Access Compliance Report Public Rights-of-Way (Curb Ramps)

Main Street: WOODSONG Cross Street: MEANDERING_TRAIL Location: E

ADA ID: RPRK211018155133 Ramp Type: Type 4 - Parallel Initial Pass/Fail: Fail Overall Compliance: No Severity Score: 30

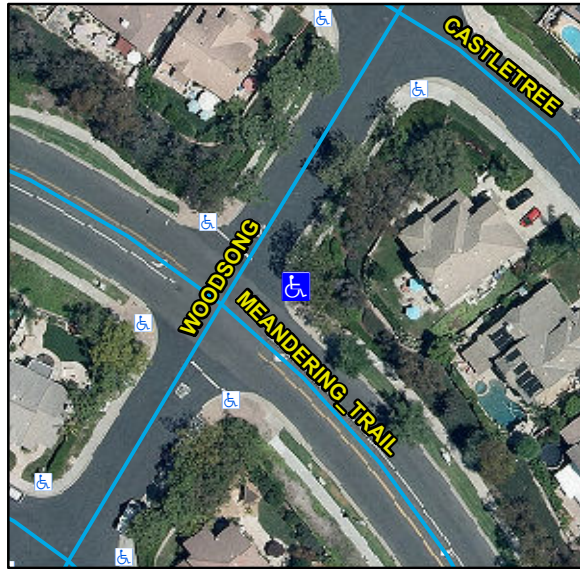
R204.3, R304.5.3, R304.3.2, STD 1115

Compliance	Description	Data	Compliance	Description	Data
N/A	Ramp Length LT (in)	58	N/A	Ramp Length RT (in)	65
Yes	Ramp Width LT (in)	82	Yes	Ramp Width RT (in)	86
Yes	Ramp Run Slope LT (%)	3.1	No	Ramp Run Slope RT (%)	8.9
No	Ramp Cross Slope LT (%)	5.6	No	Ramp Cross Slope RT (%)	5.1
N/A	Landing Present	N/A	N/A	DWS Provided	N/A
N/A	Landing Length (in)	N/A	N/A	DWS Contrast	N/A
N/A	Landing Width (in)	N/A	N/A	DWS Length (in)	N/A
N/A	Landing Run Slope (%)	N/A	N/A	DWS Full Width	N/A
N/A	Landing Cross Slope (%)	N/A		DWS Offset Type	N/A
N/A	Landing Movement Obstructed?	N/A	N/A	DWS Offset Left (in)	N/A
	Landing Movement Type	N/A	N/A	DWS Offset Right (in)	N/A
N/A	Landing Shared	N/A			
N/A	Clear Space	Yes			
N/A	Clear Space To Crosswalk (in)	N/A			
N/A	Marked Crosswalk 1	No	N/A	Marked Crosswalk 2	No
	Crossing 1 Direction	NW		Crossing 2 Direction	SW
	Marked Crosswalk 1 Width (in)	N/A		Marked Crosswalk 2 Width (in)	N/A

Remove & Replace Curb Ramp With Two New Directional Ramps or Equivalent.
